JOINT REGIONAL PLANNING PANEL Sydney West

JRPP No	2013SYW098
DA Number	DA0391/13
Local Government Area	Ku-ring-gai
Proposed Development	Construct 2 residential flat buildings comprising 88 units and basement car park and associate site works
Street Address	100 Eton Road, Lindfield – Precinct 2
Applicant/Owner	Defence Housing Australia
Number of Submissions	2 objections
Regional Development Criteria (Schedule 4A of the Act)	Schedule 4A(3)
List of All Relevant s79C(1)(a) Matters	• s79C(1)(a)(i) - Ku-ring-gai Planning Scheme Ordinance - Concept Approval MP06_0130 - SEPP No. 55 - SEPP No. 65 - SEPP (BASIX) - SREP (deemed SEPP) (Sydney Harbour Catchment) 2005 • s79C(1)(a)(ii) - Ku-ring-gal Local Centers LEP 2012 (draft instrument at time of lodgment) • s79C(1)(a)(iii) - Edgelea Urban Design Guidelines - DCP 47 – Water Management • s79C(1)(a)(iv) - Environmental Planning & Assessment Regulation 2000
List all documents submitted with this report for the panel's consideration	- Architectural Plans - Landscape Plans

Recommendation	Approval
Report by	Adam Richardson

DEVELOPMENT APPLICATION

Setbacks:

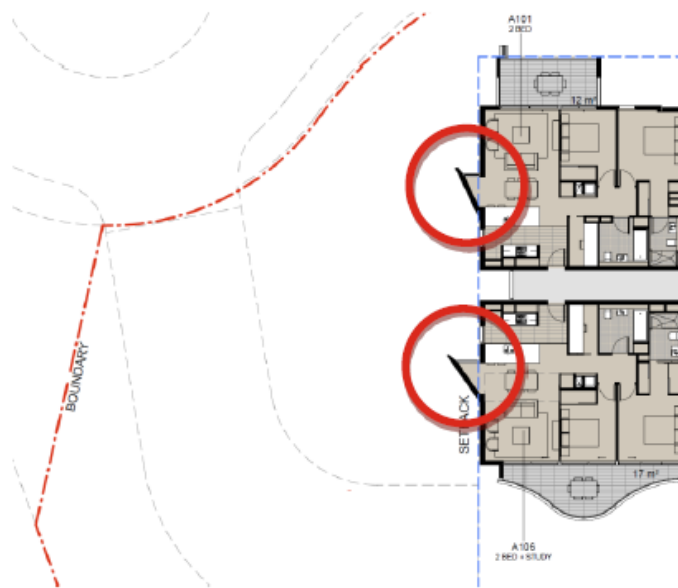
In providing articulation and visual interest to the western end of Building A, a minor setback variation to the controls of Clause 2.1.3 of the UDG's to the upper floors (Levels 2, 3 and 4) has been proposed. The variation is associated with protruding kitchen windows as detailed in the below diagram.

The variation is acceptable as the protrusions are of no impact as they adjoin the APZ and also assist with light and ventilation to the units and break up the mass of the western wall when viewed from the street. It is noted that the protrusions do not create any building separation or deep soil issues.
